REQUEST FOR INFORMATION (RFI)

PROJECT :	BKK2	R.F.I. NO. :	523213-01-RFI-AR-0015
TO :	CTA	ATTENTION :	CTA
SUBMITTED DATE:	15-Jan-26	NEED REPLY BY DATE :	22-Jan-26

SUBJECT : Request for Confirmation - Confirm Ceiling Type 6th FL (C4 or C10)

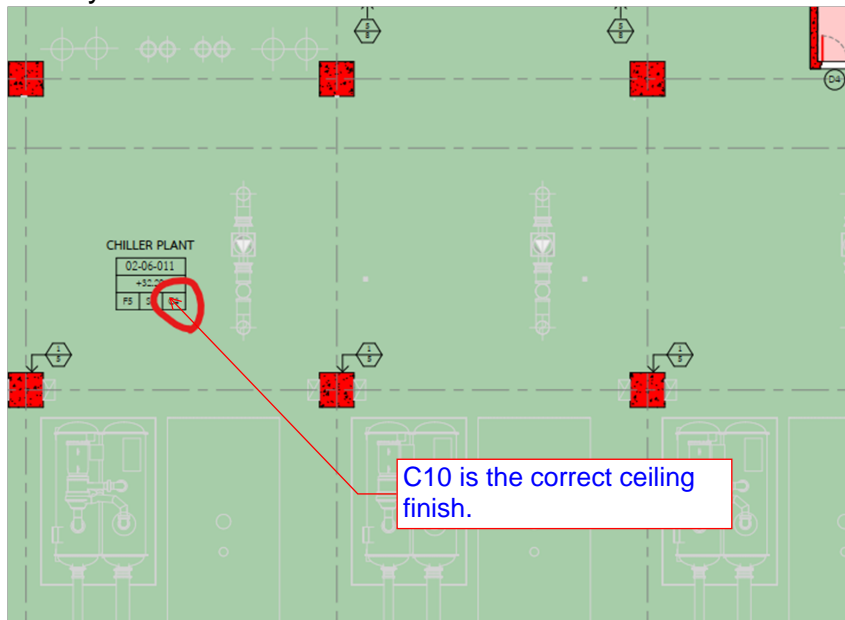
Ceiling type for Chiller Plant Room in L6 is different between layout plan and reflected ceiling plan.

Please confirm which type to be used.

Note : Concur with SLA's response with acoustic work as indicated on drawing

SLA: The ceiling finish C10 is the correct Chiller room ceiling specification.
